MANDATORY SERVICE BULLETIN**NUMBER:** SB-007**DATE:** 4/2/2009**SUBJECT:** AMSAFE MANDATORY INERTIA REEL TEST**SUMMARY****RECURRENT REQUIREMENTS**

INSPECTION / CHANGE OF RESTRAINT SYSTEM ASSEMBLY
WITH INERTIA REEL AND MANUAL LOCK HANDLE

SERVICE BULLETIN NUMBER 4119-25-01 ISSUE 1

Figure 1 – Serial Number and Date Code Information

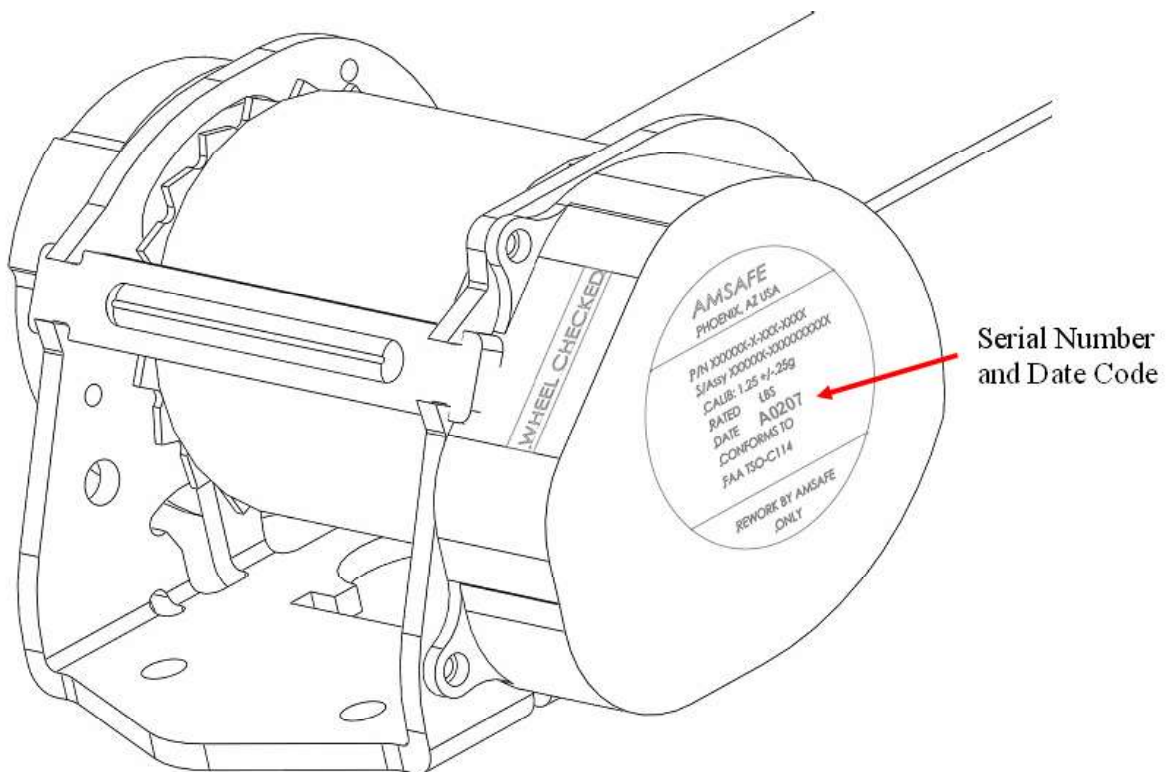
1. The inspection of the restraint system does not require the restraint system to be removed from the seat.
2. Date Code Inspection. The date code can be found on the inertia reel identification label see Figure 1. For access to the inertia reel identification label please refer to the applicable seat manufactures instruction defined in their CMM.

If the date code is prior to 1 Feb 07 (X0207) or after 30 Nov 08 (X1108) no further action is required.

Figure 2 – Wheel Checked Label

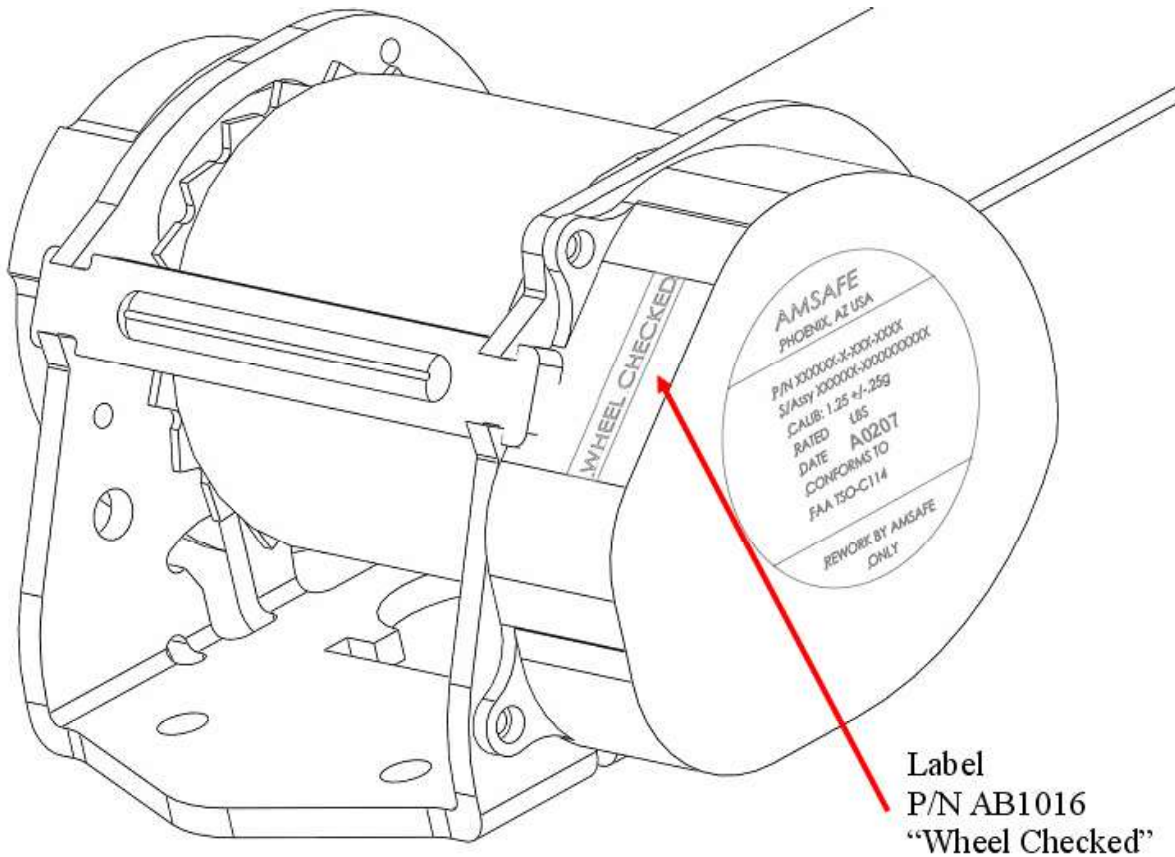
If the serial number is between 1 Feb 07 (X0207) and 30 Nov 08 (X1108), and the inertia reel does not include a label attached by AmSafe stating "Wheel Checked" (Figure 2) continue to step 3.
